Application for Certificate of Appropriateness

Address of Subject Property: 971 Oakdale Road

PROJECT:
KINSELL RESIDENCE

From: [Davis Bishop](#)
To: [Paige V. Jennings](#)
Cc: [Michael DeCarlo](#); [Brian Field](#)
Subject: Re: Questions Regarding Application for 971 Oakdale Road
Date: Wednesday, May 14, 2025 4:52:53 PM
Attachments: [image001.png](#)
[250514 - 971 Oakdale Rd plans for COA Review.pdf](#)

DRAWING TITLE:
COA PERMIT SITE PLAN

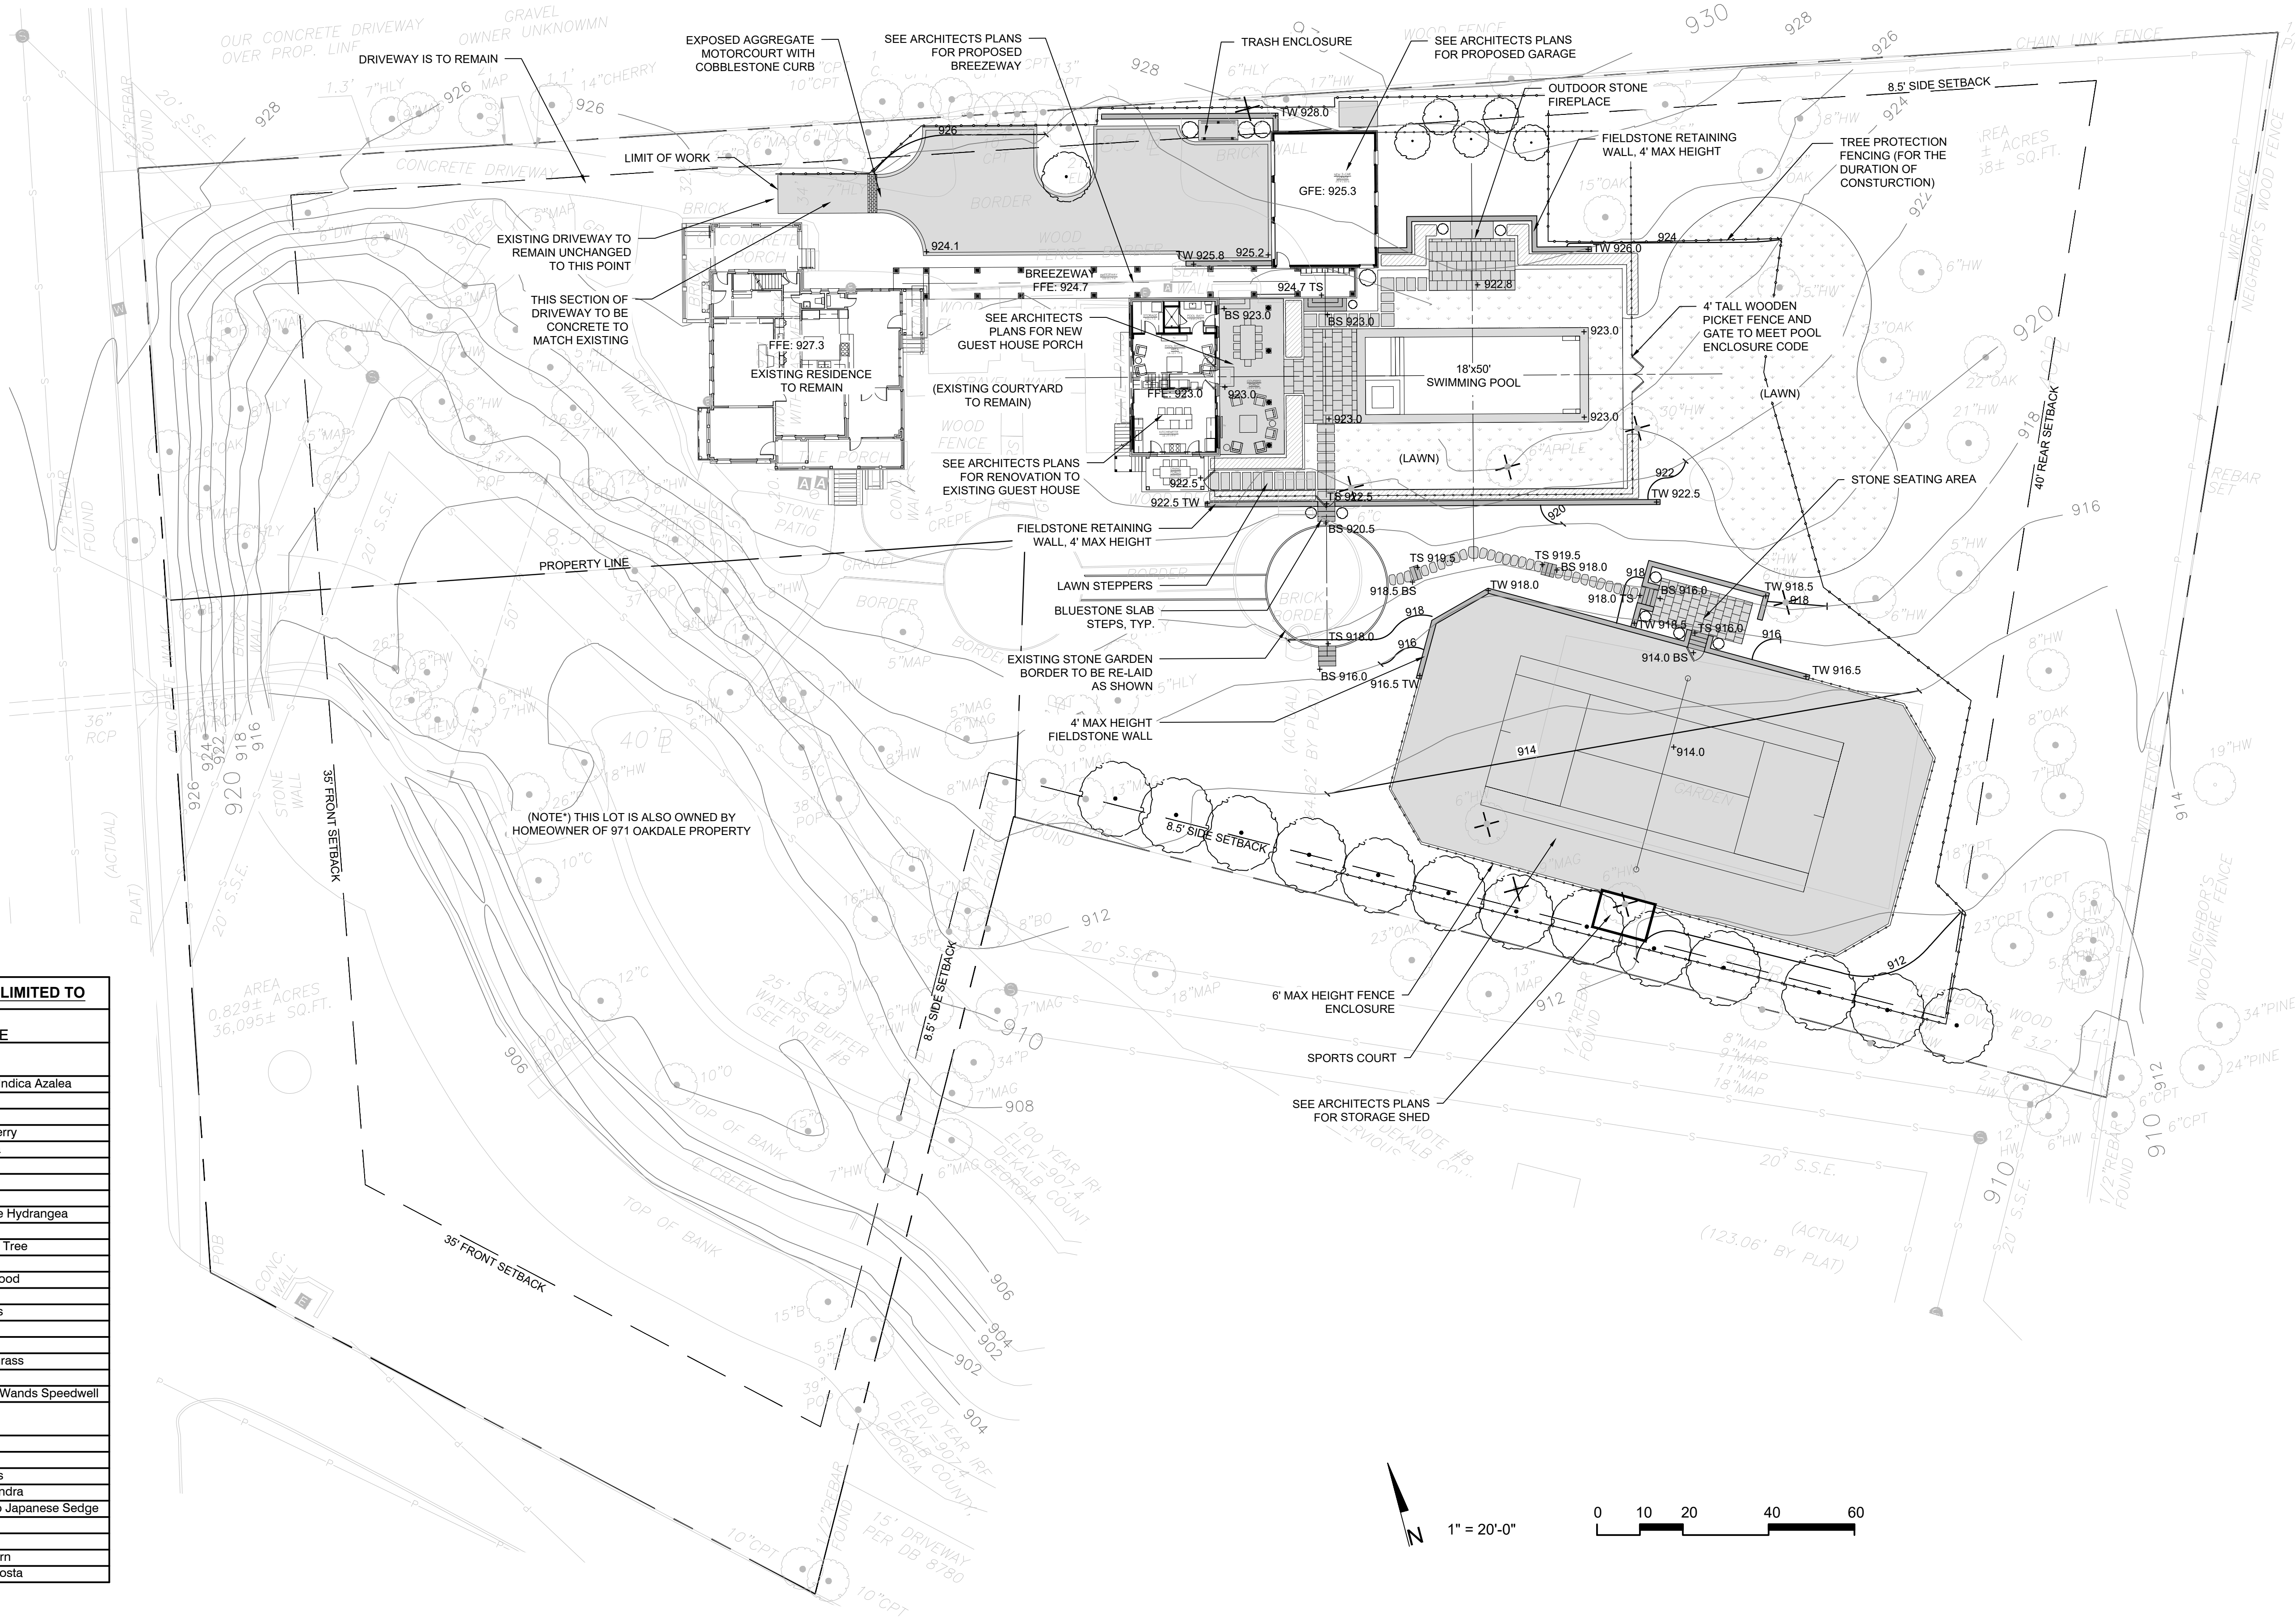
2. The current proposed site plan does not show the neighboring properties; can you provide an updated site plan to show the neighboring properties and their proximity to the proposed work?

5. What is the square footage for the proposed storage shed?
6. What are the proposed modifications to the existing driveway? Will the driveway be expanded or reduced, and if so, what is the current size of the driveway and how will its size be modified?

2. The current proposed site plan does not show the neighboring properties; can you provide an updated site plan to show the neighboring properties and their proximity to the proposed work? - [Neighboring properties have been outlined and added to the site plan.](#)

6. What are the proposed modifications to the existing driveway? Will the driveway be expanded or reduced, and if so, what is the current size of the driveway and how will its size be modified? - The existing driveway is a total of 4,458SF, and the proposed size after modifications will be 3,843SF. The existing driveway will remain unchanged up to the point of the existing covered porch corner, approximately. After this point, the existing driveway is to be removed and the footprint reduced and modified to connect to the newly proposed garage. The adjustments to the driveway can be seen between the existing survey and the hatched design on L-1.00.

EXTERIOR
ELEVATIONS
- PROPOSED

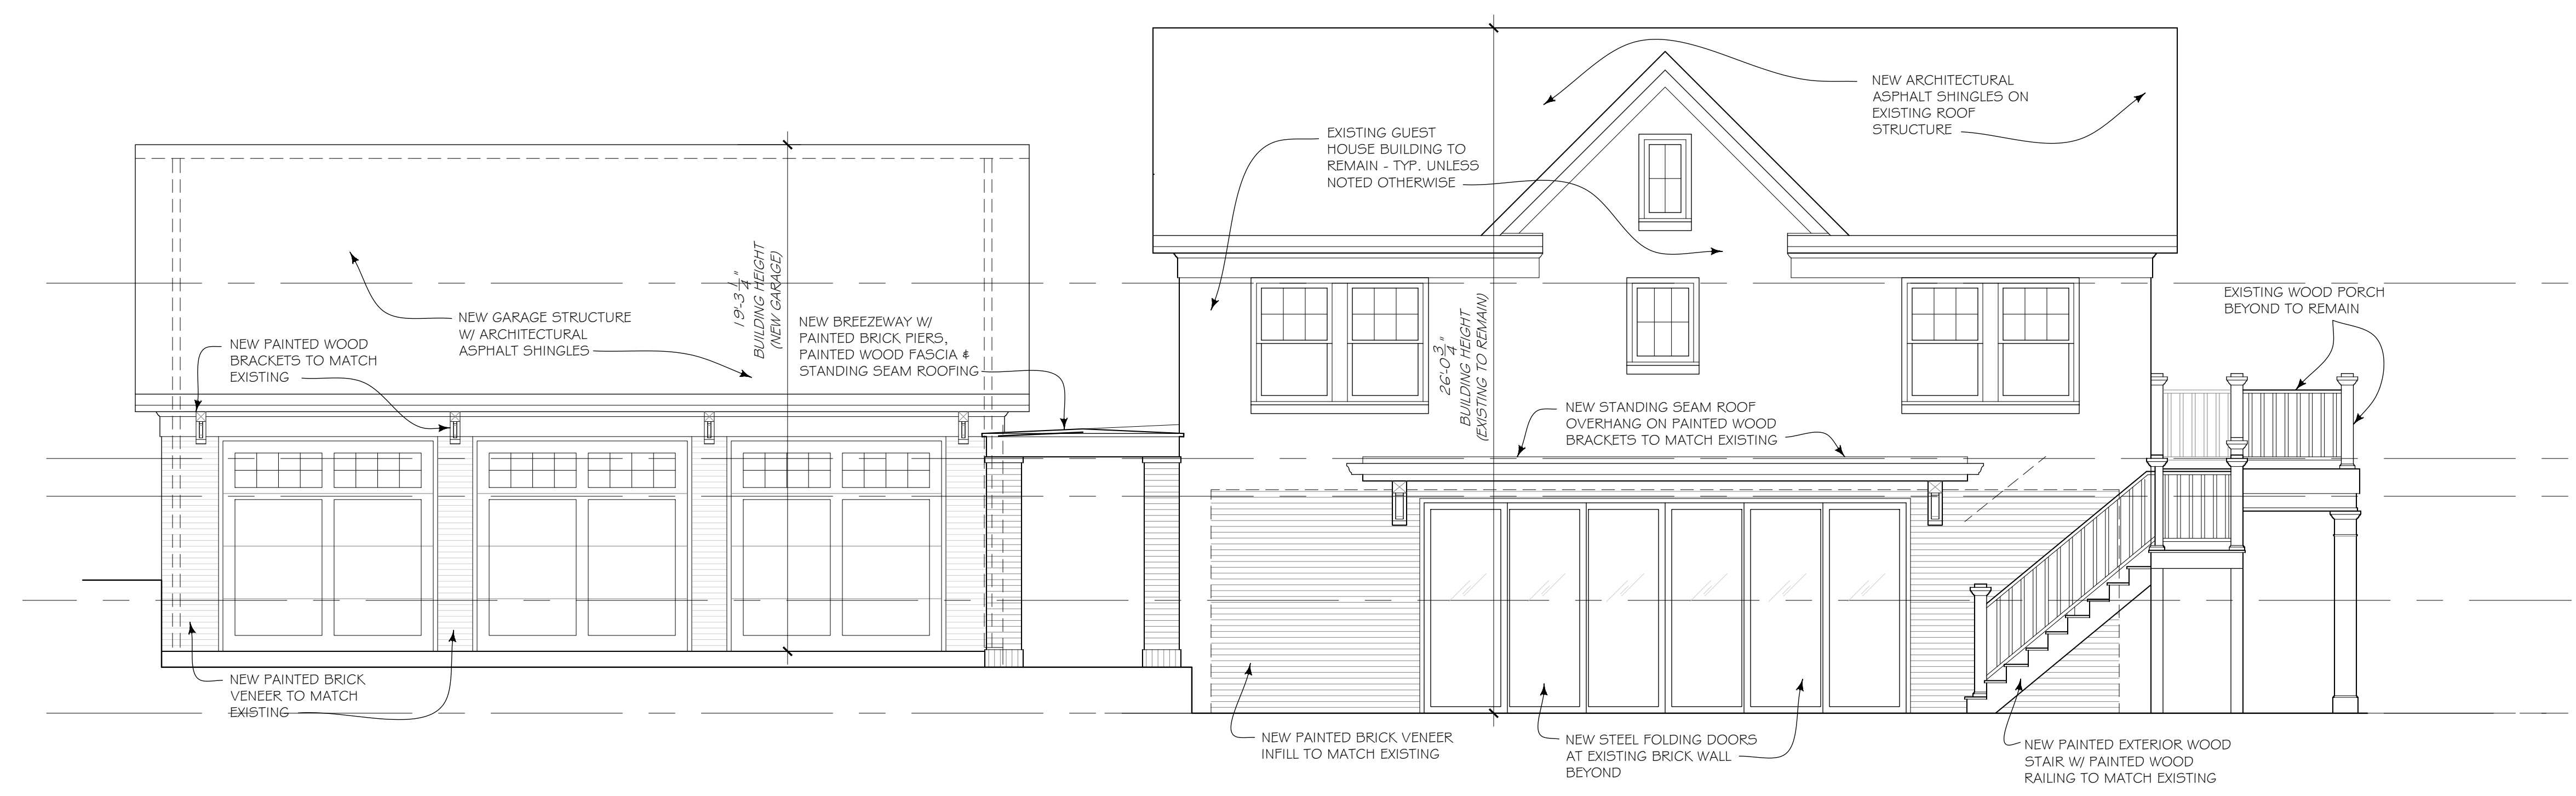
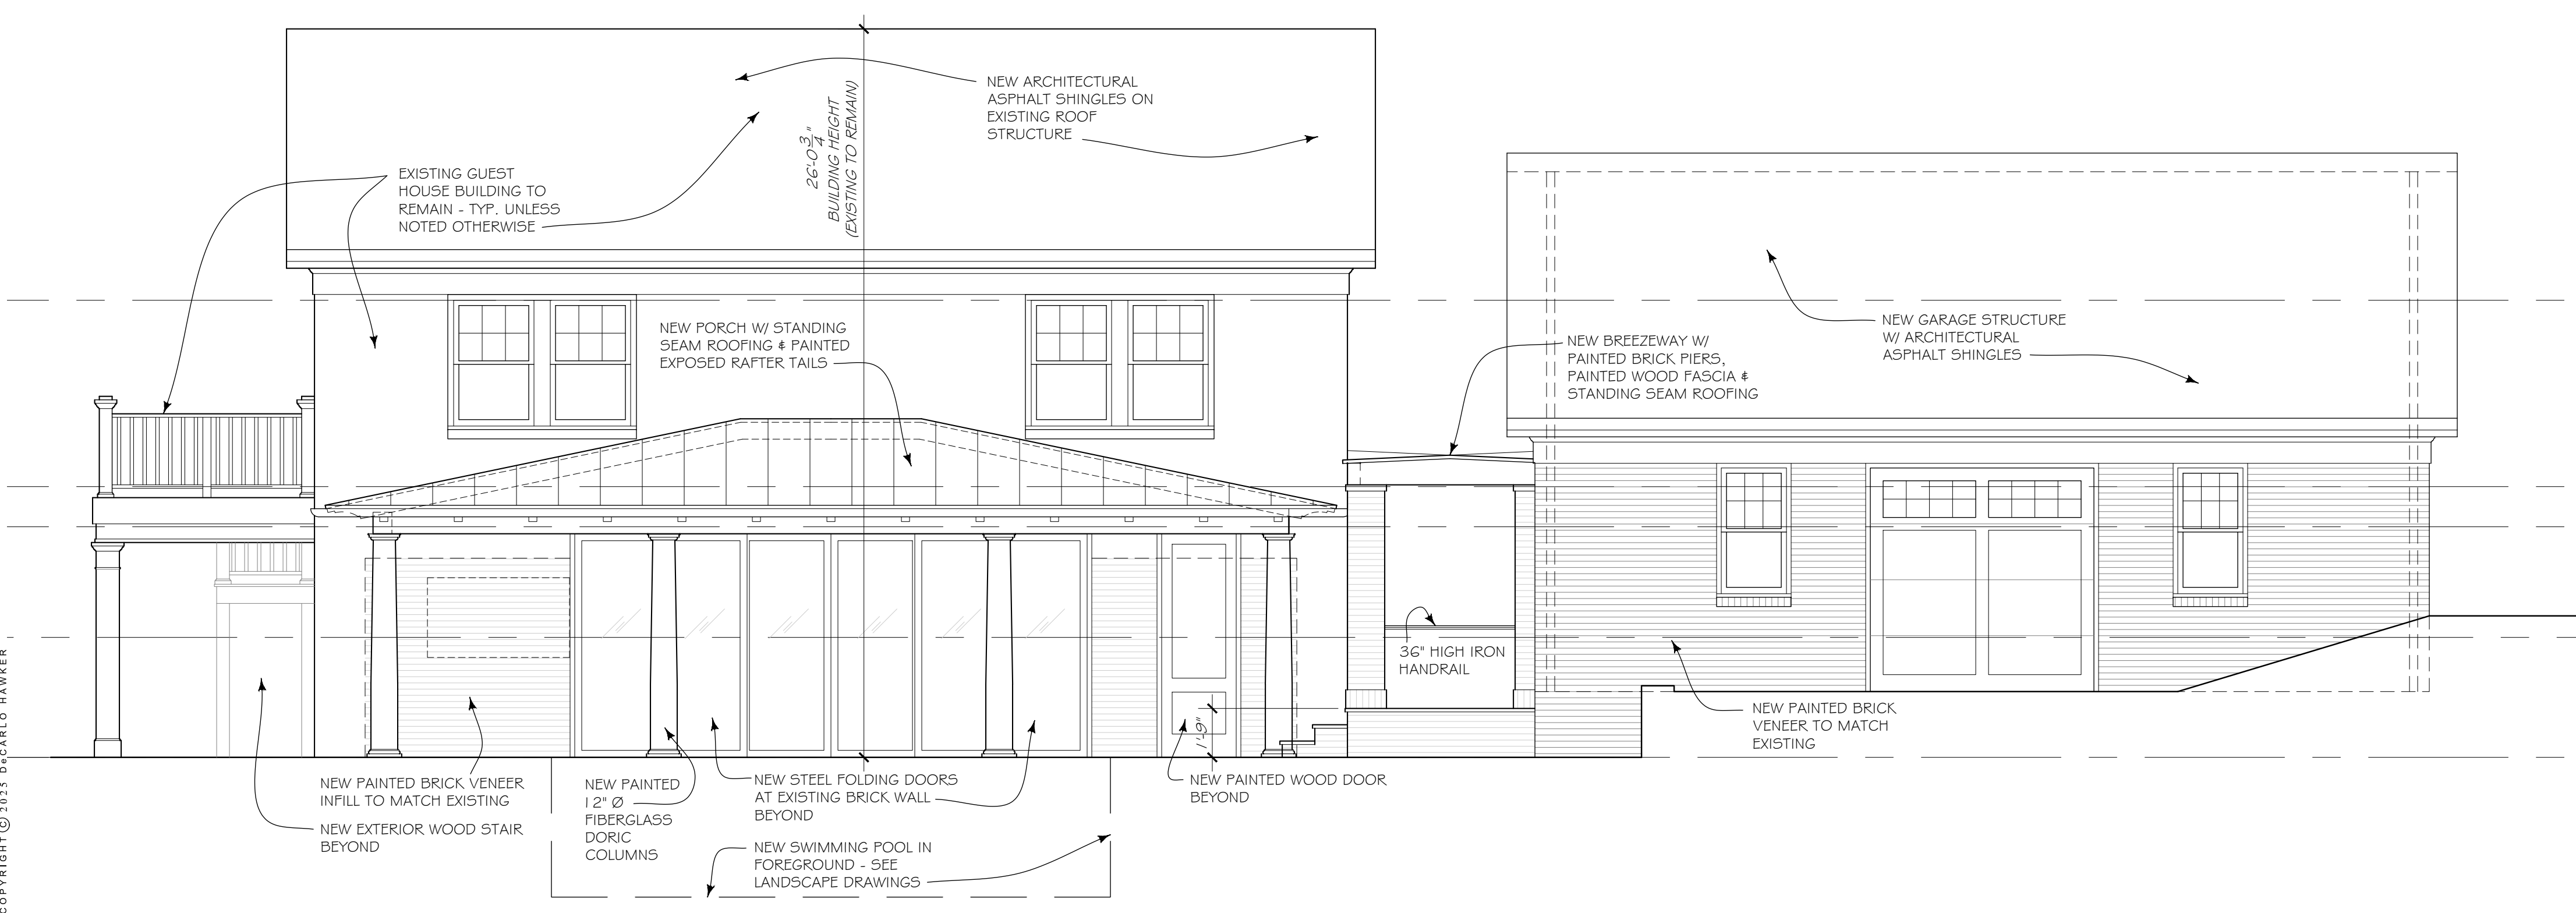
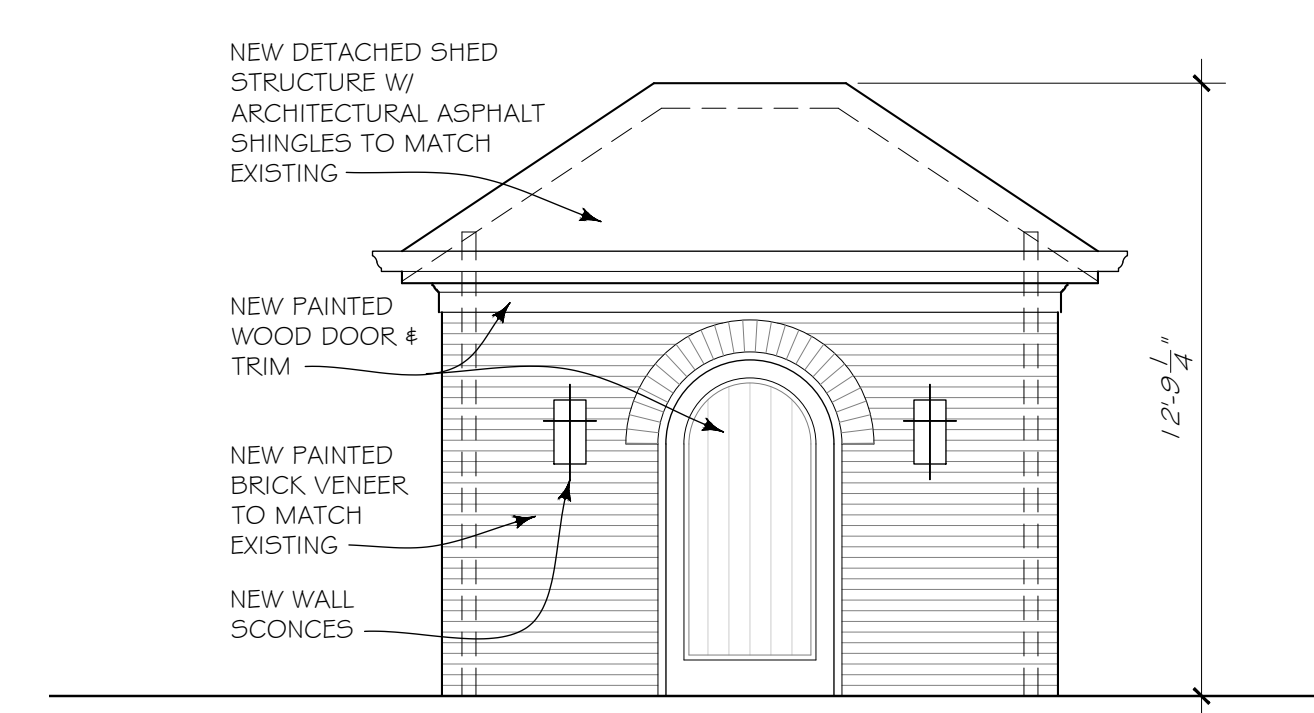
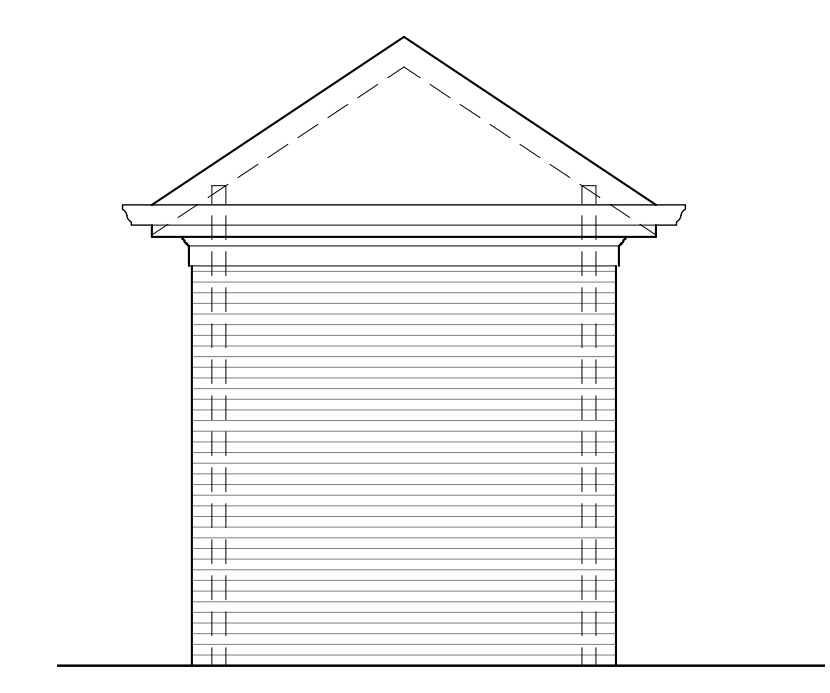
1. Can you provide individual drawings to show the existing and proposed elevations of the renovated guest house with notes regarding the proposed changes in the exterior materials and design?

1. Can you provide individual drawings to show the existing and proposed elevations of the renovated guest house with notes regarding the proposed changes in the exterior materials and design? - [Please refer to sheets A2.4 & A2.5 for existing elevations of the guest house. The elevation drawings and accompanying notes on A2.1 & A2.2 show the existing vs. proposed material and design changes.](#)
